PLANNING COMMISSION MEETING TUESDAY, April 11, 2023 6:00 P.M. Council Chambers 40 W MAIN ST, NEWARK, OH 43055

## CITY OF NEWARK PLANNING COMMISSION STAFF REPORT

1. PC FILE 23-06: SITE PLAN FOR HEATH-NEWARK-LICKING COUNTY PORT AUTHORITY - STEMFLEX DEVELOPMENT PHASE 1, 1401 MT VERNON ROAD

STEMFLEX DEVELOPMENT PHASE 1 CONSTRUCTION PLANS

# SCHEMATIC PLAN

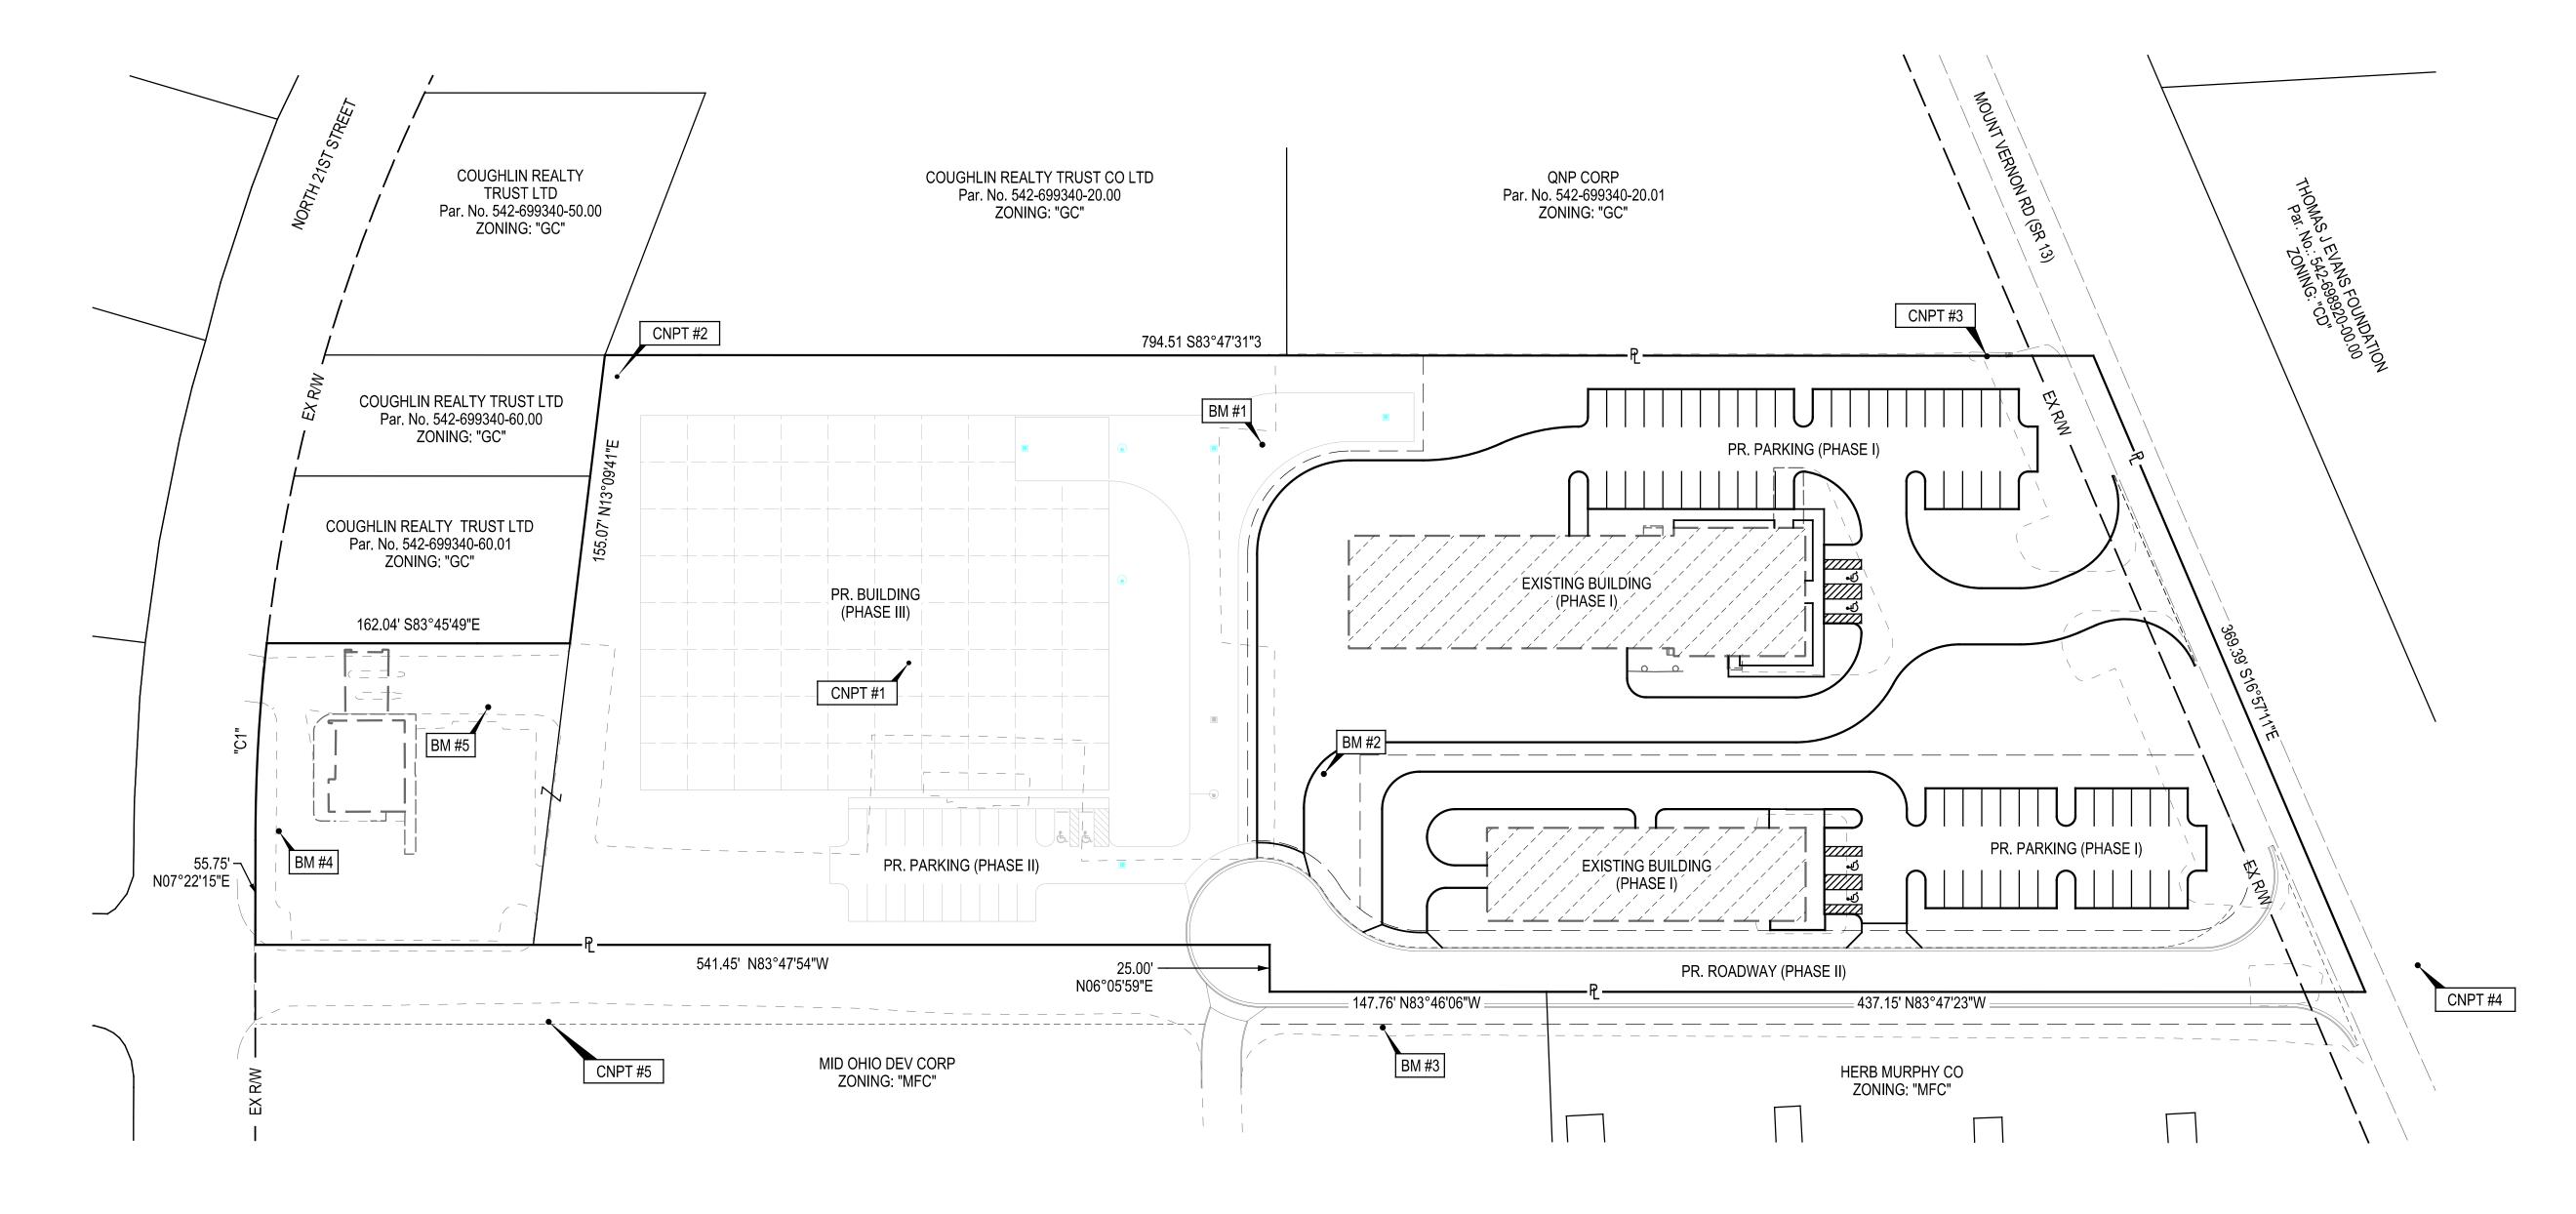
The existing site is legal non-conforming with regard to the landscape requirements, as there is limited landscaping on this site; nearly the entire parcel is covered with asphalt pavement. The proposed redevelopment will greatly reduce the amount of asphalt pavement on the site, which will be removed and replaced with grass and 17 trees. A landscaping plan has been submitted, and the green space / ground cover area measurements should be shown on the plan. Any additional buffering and screening will need to be addressed on the Phase 2 public road plan.

Changes to the driveways and parking areas will affect the traffic flow around both buildings; the changes will separate the parking and drive areas for each building.

Given that the exact use of these buildings is unknown at this point, from a traffic perspective, we will want to look at the need for a turn lane on Mt. Vernon Road with the Phase 2 and 3 developments. The pavement width at Mt. Vernon Road may need to be widened, and the design and right-of-way platting should anticipate turn lanes at this intersection. The City will want cooperation with the Port Authority to construct turn lanes if the future traffic on the site warrants the improvement.

For Phases 2 and 3, there was a preliminary discussion to evaluate the existing sanitary sewer on the north side of the site, in order to consider converting it to a publicly owned line, given that separate owners would be connecting to it. If this occurs, the appropriate easements should be included on the Phase 2 plat.

- 1. Landscape green space and ground cover area measurements are shown on the plans.
- 2. Compliance with City's Stormwater Management requirements, to ensure runoff water does not adversely impact adjacent properties.
- 3. Any of the remaining issues listed above will be addressed on the final construction plans.

# STORMWATER MANAGEMENT DETAILS

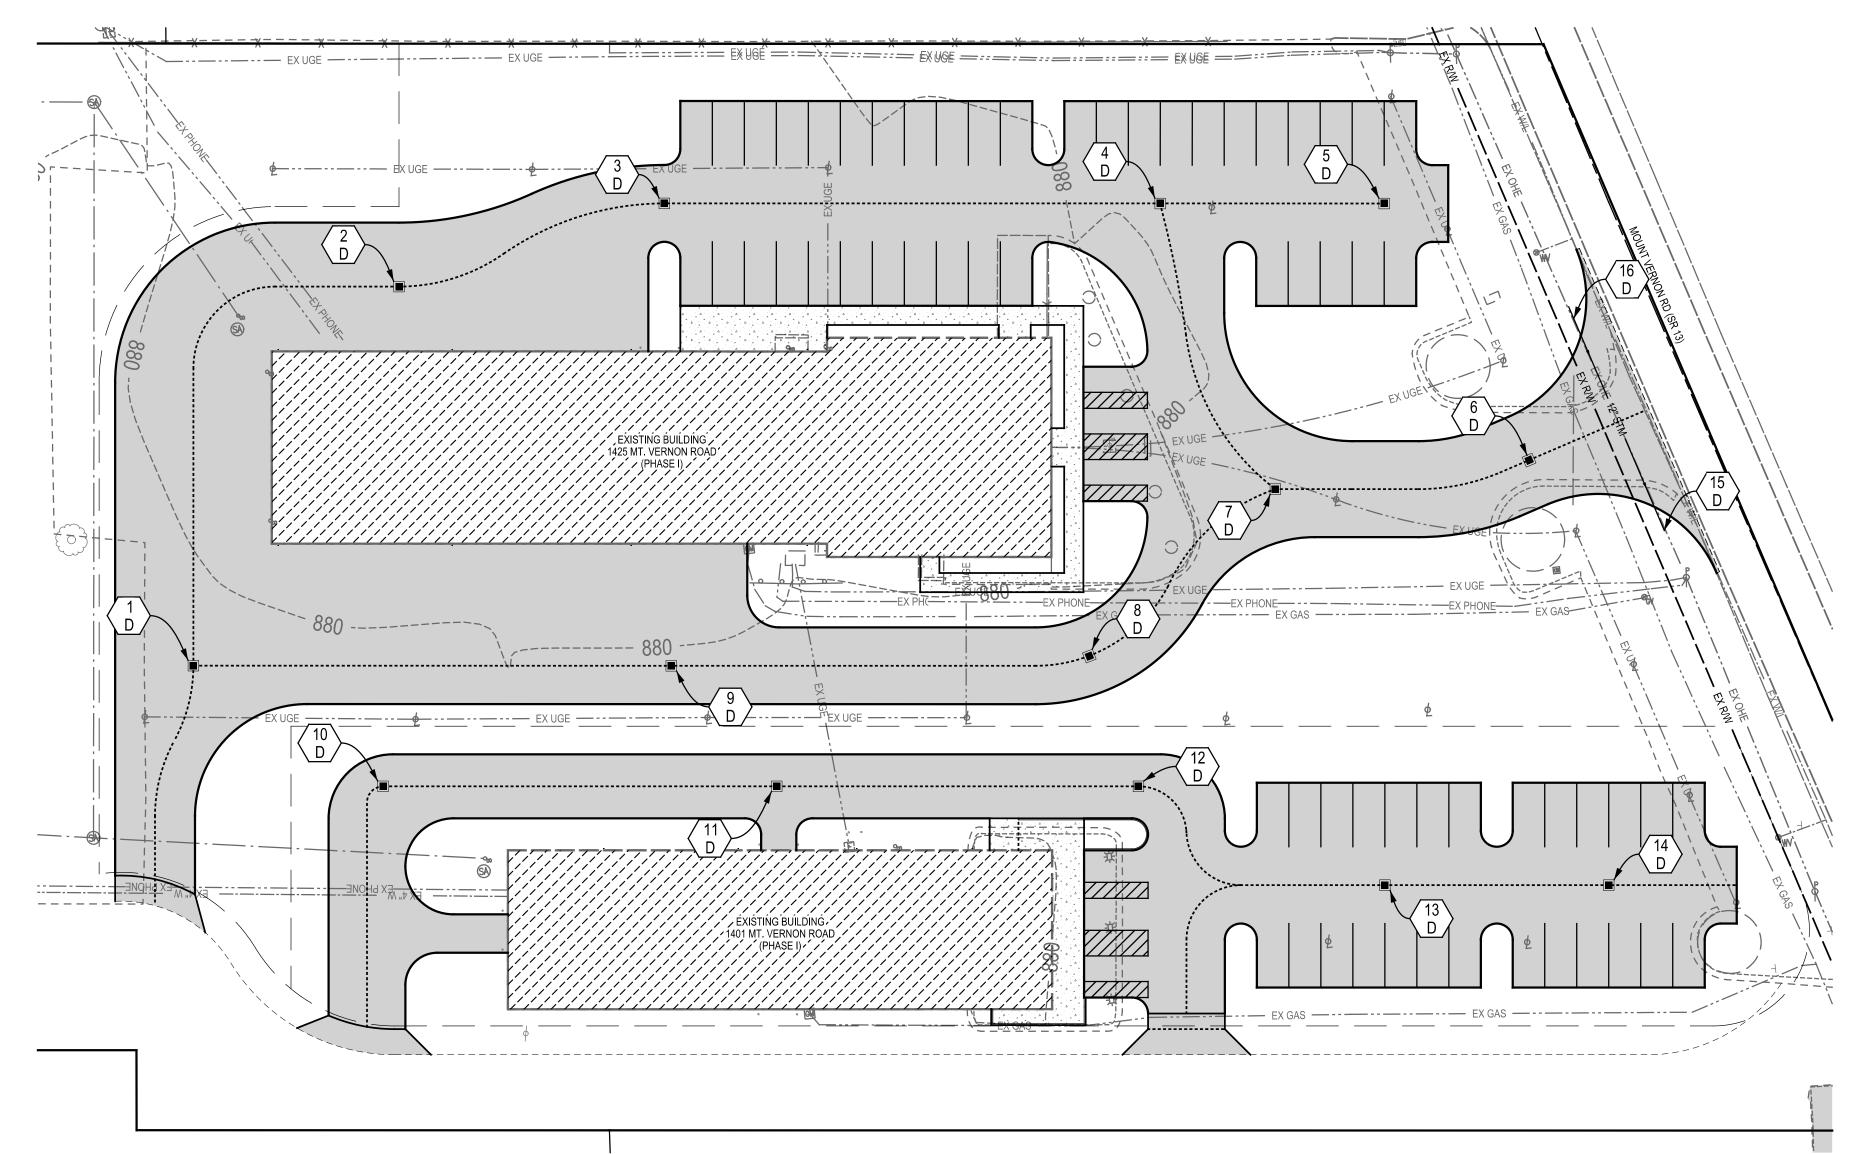
There has been a stormwater management plan submitted, and the decrease in impervious area with this redevelopment is considerable. Engineering is currently reviewing this plan to comply with the City's Stormwater Management requirements. There is no public storm sewer nearby, so the design manages the stormwater on this site.
